21 August 2011

Submission Re Code of Practice Ground Control in Open Pit Mines

Figure 1 Slope Design Process from Stacey (2009).

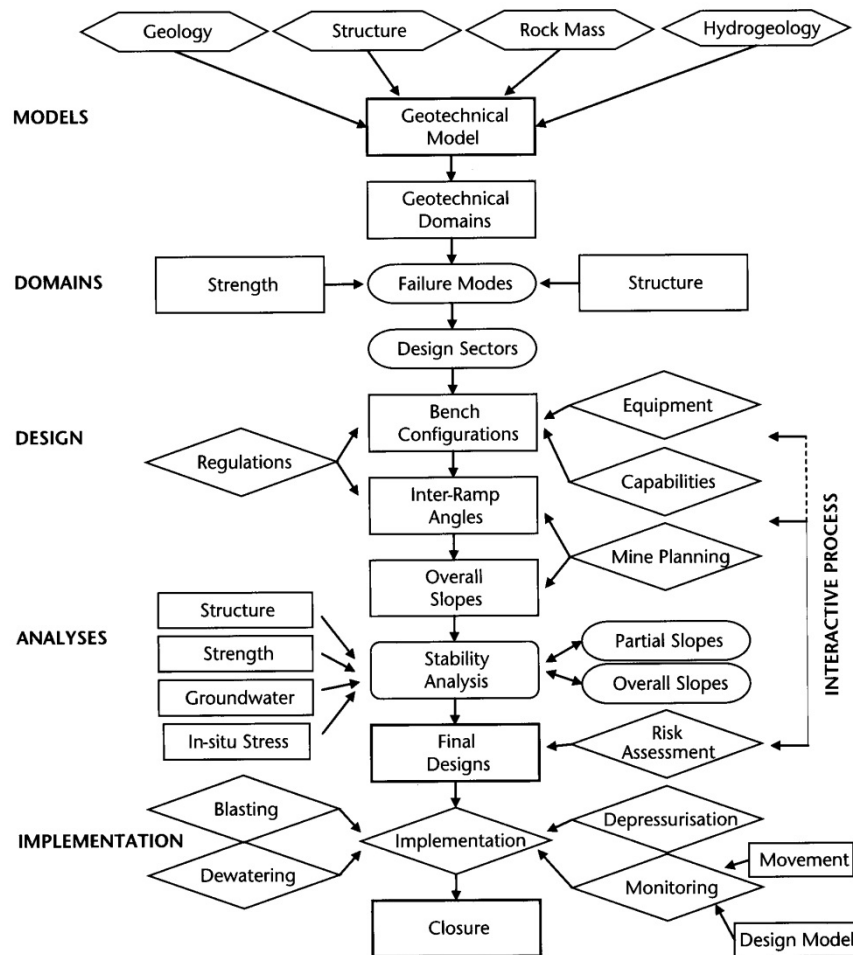
Despite introductory comments in the Foreword and, Scope and Application, it is not clear for whom the DC has been prepared. If it is supposed to provide technical guidance, the DC is inadequate and should simply have referred the reader to Read and Stacey (2009), amongst others, for current guidelines. If, as stated the document has *been "prepared to ensure that the mine operator at an open pit mine has undertaken adequate consideration of all ground control aspects..."* I would argue that (a) a document cannot ensure anything and (b) a check list without a brief technical commentary would be more appropriate. Stacey, 2009, Fig 1.4 provides a flowchart, shown below as Figure 1, that can be used as a high level check list for the mine owner.

Figure 2 Pit wall terminology from Stacey (2009).

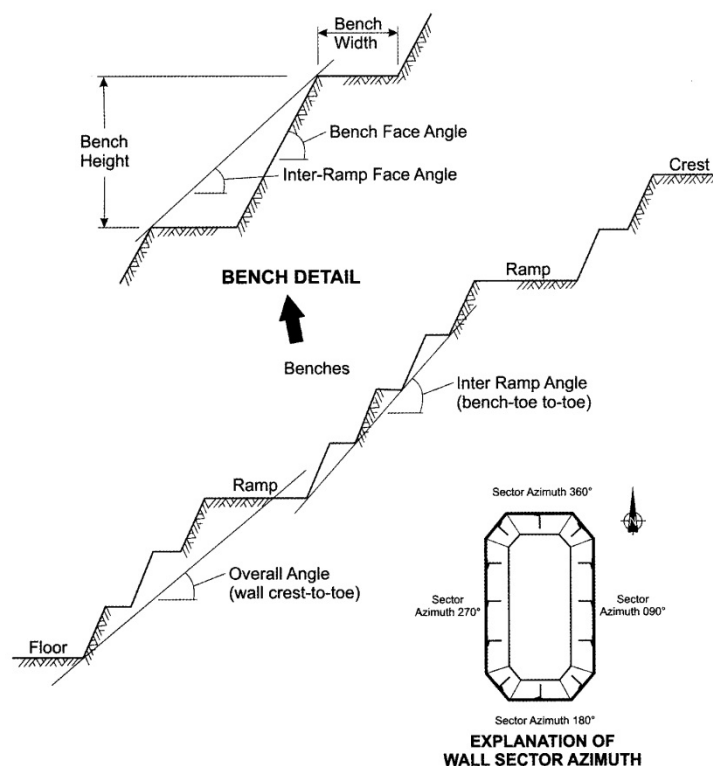
p 7, figure 1,

There would be some controversy regarding the inter-ramp slope angle as shown. Many would prefer to use the definition of inter-ramp angle shown in Stacey (2009), Figure 1.3 and shown below as Figure 2. Stacey (2009) states:

Note that the bench of face angles are defined between the toe and crest of each bench, whereas the inter-ramp slope angles between the haul roads/ramps are defined by the line of the bench toes. The overall slope angle is always measured from the toe of the slope to the topmost crest
